Dear Authors,

This article needs significant work to be accepted. I think the work is interesting so I will recommend major revisions. The revisions that are necessary will make the article look like a completely new submission.

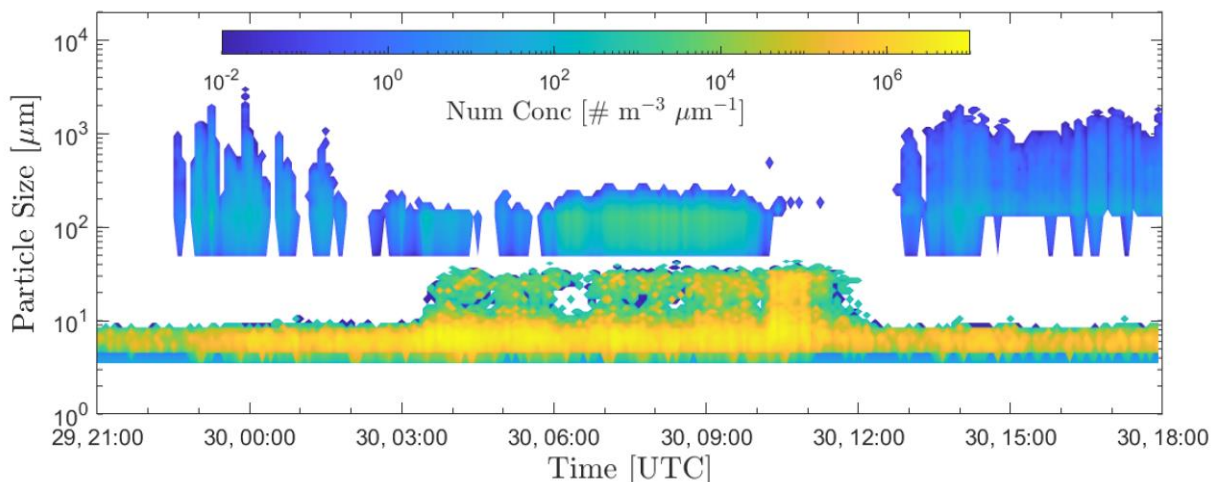
Figure 2: Text is very small and colors are random. In an earlier section the authors mentioned a difference in profiles between day and night. It would make sense to separate these figures based on day and night. Having the colors be a gradient from start time to end time would greatly improve readability. The authors could also consider a height time concentration plot. See example below except instead of particle size on the y-axis you will have your elevation above ground. It is also unclear how these profiles were taken, was the tethered balloon raised to 2.5 km above ground level and back down at each time stamp? There are no labels on the panels of this figure, and the caption does a poor job of

describing what the reader is looking at. I've also included a caption below the example figure so the authors can understand what a caption should include

Figure X: Time series of bin-wise droplet concentration from the FM120 and FD70. During the periods of fog (0300 – 1200) we see significantly fewer larger particles from the FD70 and towards the end of the period (1100) we see the evaporation of all larger particles which result in the broadening of the peak of small particles.
